PL2023-146
PL202300146

ENCLAVE BLOOMINGTON 494
BLOOMINGTON, MN

SITE PLAN

1 SD Site Plan
1" = 80'-0"

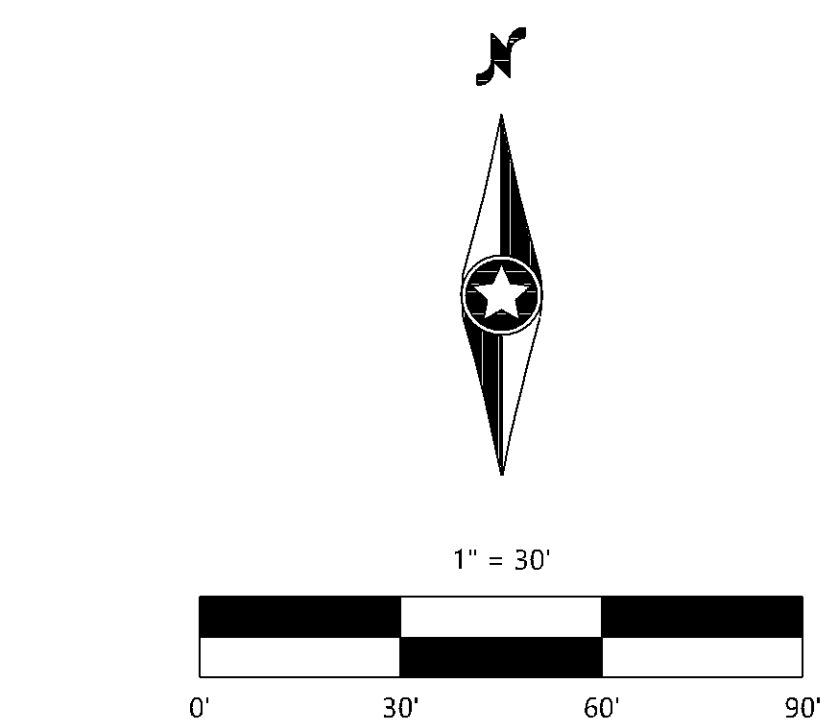
Must meet 2020 MN
State Building Code

Building plans must
be signed by a MN
licensed architect.

SAC review by MET council
will be required.

Must meet 2020 MN
Accessibility Code.

Provide a detailed code
analysis with the plans.

Hydrant coverage shall be provided within 50' of the
FDC and within 150' of all portions of the structure.

Access shall be provided to/from
all stairwells on all floors and
parking levels.

Emergency responder radio coverage meeting
the requirements of Appendix P in the 2020
MSFC shall be provided throughout the property
and within the structures.

Hydrant coverage shall be provided
within 50' of the FDC and within
150' of all portions of the structure.

Ensure landscaping
doesn't interfere with
access to the building,
hydrants and/or FDC.

Appliances/cooking producing grease
laden vapors requires a hood and
suppression system.

Building/property shall be adequately
signed for emergency response.

Proposed pool must be approved by the
Minnesota Department of Health prior to
construction.

Provide an Environmental Health Plan
Review application with plan submittal
for each proposed food facility.

Provide adequate turning radius for
all emergency vehicle access lanes.

All exterior doors that allow access to the
interior of the building(s) shall be numbered
in a sequential order starting with the main
entrance (public entrance) as number 1 and
continue in a clockwise manner.

A looped water supply feeding a single,
combined water service is required for the
domestic and sprinkler system water demand.
